**Commentor No. 501: Sam Adams, Mayor,
City of Portland, Oregon**

Thank you for the opportunity to comment on the Hanford Tank Farm Closure and Waste Management Environmental Impact Statement (EIS). Hanford is the world's largest and most complex environmental cleanup project, so I appreciate the complexity of the task ahead of the USDOE in proposing actions to clean up this facility.

Figure S-16. Lifetime Radiological Risk for the Drinking-Water Well User at the Core Zone Boundary due to Releases from the Six Sets of Cribs and Trenches (Ditches)

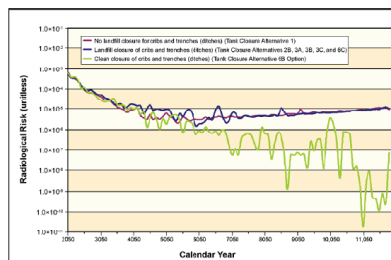
Figure S-16 shows long-term radiological risk from releases from cribs and trenches. Clean closure of cribs (Alternative 6B, light green trace in the figure) includes removal of the contamination sources in the vadose zone. The long-term radiological risk shown on the plot, reflects conditions resulting from an absence of groundwater cleanup. This supports the contention on page S-92 that “Cribs and trenches are major contributors to potential long-term groundwater impacts for all Tank Closure alternatives due to early discharges . . .” That is exceptionally true if the groundwater is not cleaned up under the clean close scenario and one drags this groundwater contamination into the risk model that is used to represent a clean closure scenario.

On page S-96 it states that Figures S-16 and S-17 show that clean closure would provide little reduction in long-term impacts to groundwater before CY6000 due to past leaks and cribs and trenches. This is only true because their clean closure scenario is not a clean closure. Under Alt 6A&B with option, the groundwater contamination from past leaks is not remediated and is included in the clean close alternative risk calculation creating substantial risk. As a result, when you compare the relative risks, there is little reduction in long-term impacts to groundwater resulting in the false conclusion of the true benefit of an actual clean closure scenario.

Figures S-16 and S-17 are terribly misleading without a clear explanation of what contamination is and is not represented in the radiological risk determination. DOE's argument of only incremental decrease in radiological risk with clean closure is not a valid argument when comparing it against the risk from an alternative that includes cleanup of the groundwater during and following the retrieval period.

The Summary, which the commentor is referring to, provides an upper level presentation of the results of the *Draft TC & WM EIS*. Chapter 5 and Appendix Q of the *Draft TC & WM EIS* and again in this *Final TC & WM EIS* presents the human health impacts related to tank farm operations, retrieval and closure. The first type of release presented is the past practice of direct discharge of liquid to cribs and trenches (ditches). The second type of release presented is due to past activity at the tank farms and includes past leaks from damaged tanks. The third type of release presented is due to future activities and includes leaks during retrieval of waste from the tanks, and long-term leaching of waste material in tanks and ancillary equipment and the results are presented beginning

Figure S-17. Lifetime Radiological Risk for the Drinking-Water Well User at the Core Zone Boundary due to Past Leaks at Single-Shell Tank Farms

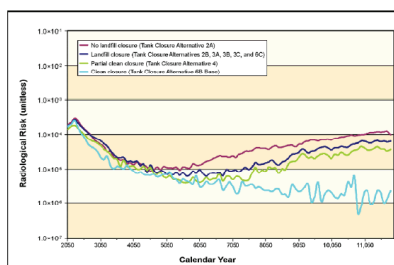
Figure S-17 shows the long-term radiological risk from past leaks at the tank farms. On page S-93 it indicates that clean closure of the SST Farms means that contamination from past leaks would be removed at all SST Farms. However, groundwater contamination remains and it is left to the reader to figure out that the blue trace in Figure S-17 results from the absence of groundwater cleanup. On page S-93 it states "Past leaks are major contributors to potential long-term groundwater impacts".

Figure S-18: Lifetime Radiological Risk for the Drinking Water Well User at the Core Zone Boundary due to Releases from Tank Farm Residuals and Ancillary Equipment and to Retrieval Leaks

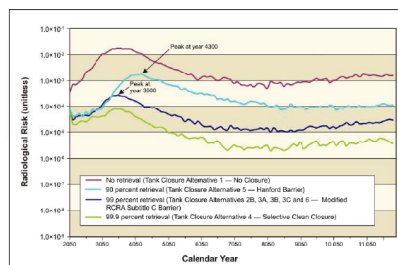
Figure S-18 shows the tank farm closure risk from drinking groundwater at the core zone. Specifically absent from that graph is a plot for Tank Closure Alternative 6B because "there are no long-term human health impacts..." because the "groundwater sources ... are completely removed under this alternative" pg S-95. In other words, when you remove the contamination, the long-term risk is gone. That concept of clean close as applied to Tank Closure also needs to be applied to the closure concept for the crib and trench sources and for the past leak sources.

Figure N-5. Time Series of Measured Gross Beta Activity Below the BY Cribs

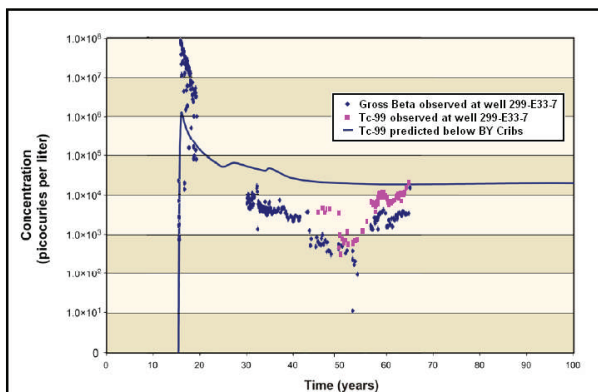
It doesn't appear to us that the activity level measured and predicted for technetium-99 for the BY Cribs are "in general agreement." In the late 1980s and early 1990s, the predicted activity appears an order of magnitude too high. This comparison suggests that the set of values for the vadose zone hydraulic parameters have underestimated the flux of Tc-99 through the vadose zone from discharges to the BY Cribs.

Observed versus predicted Tc-99 activity in groundwater below the BY Cribs as shown in the EIS. Figure N-5 is superimposed on Figure N-6

DOE recognizes that it is difficult to compare the historical data presented in Figure N-5 to model results in Figure N-6 of the draft EIS. This has been revised in this *Final TC & WM EIS* by presenting both on the same graph, Figure N-12. DOE would like to clarify that the comparison of these two data sets is a "qualitative agreement." DOE believes this qualitative agreement is evident in that the observed data show gross beta and the predicted technetium-99 peak in the mid-1950s, with concentrations falling off rapidly thereafter and ending in the 1970s. Given the log scale, the size of the initial peak, and approximate agreement even over long periods, qualitative agreement is a reasonable characterization. There indeed may be trend as a result of flows from a distant source to the well, but that trending value is still of the same order of magnitude. Thus, there are two points to be made in this regard: first, there is qualitative agreement; and second, the structure evident in the field data is not explained solely by the BY Crib model. Note in Figure N-5 of the draft EIS that the technetium-99 activity exceeds the gross beta. Explanations for this range from measurement uncertainties to multiple and distant sources. Appendix N has been revised in this final EIS to provide this additional explanation.

Figure 1. Index map of the 216-B-12 area and uranium groundwater concentrations.

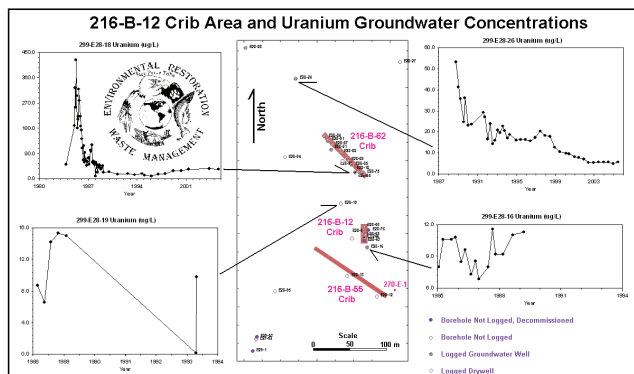
The occurrence of a uranium groundwater plume (Figure 1) near the 216-B-62 crib is problematic. Its origin is the 216-B-12 crib, which is located approximately 150 m (500 ft) to the south (Figure 1). According to the Hanford Soil Inventory Model (RPP-26744), discharges of uranium at the 216-B-12 crib are estimated at 15,100 kg, which ranks as the fifth largest release of uranium at Hanford. The discharges to the crib occurred between 1952 and 1957 as well as 1967 to 1973. The 216-B-62 crib is estimated to have received 1.04 kg of uranium (RPP-26744) and releases occurred in the November 1973 through September 1991 time period. Uranium (treated essentially as being immobile by DOE) from the 216-B-12 crib has travelled more than 300 ft vertically to reach groundwater and 500 ft horizontally.
